SIB 61 11 21

SERVICE ACTION: CHARGING FAN DIODE RETROFIT

2021-11-23

► **Installing flyback diode for fan**

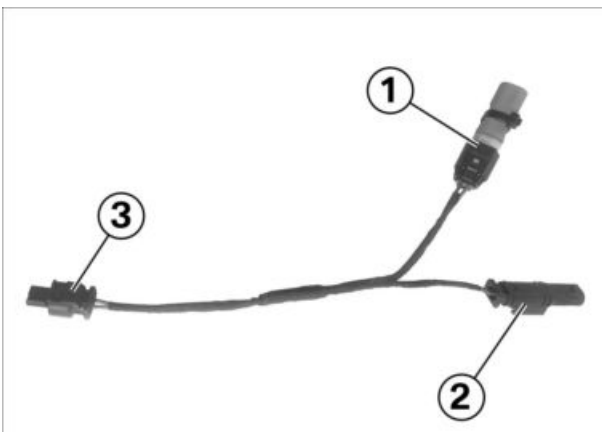
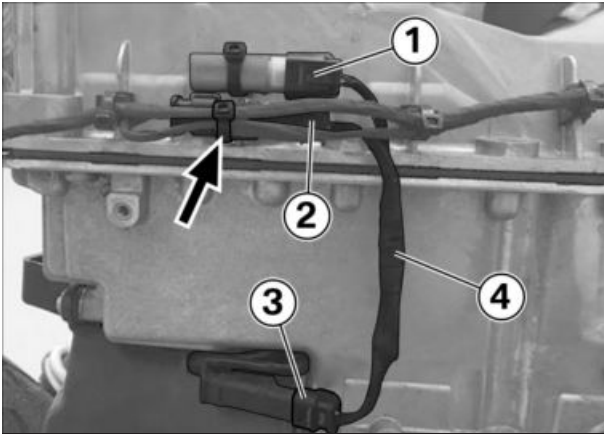
- Disconnect connector **(1)** for the fan.
- Install cable holder **(2)**.

- Overview of additional wiring harness for flyback diode.

- Connector **(1)** flyback diode.
- Connector **(2)** to wiring harness.
- Connector **(3)** to fan.

- Connect connector (3) with connector for fan
- Connect connector (2) with wiring harness.
- Route additional wiring harness (4).
- Secure flyback diode (1) with cable clip.
- Secure the cable strap (arrow).
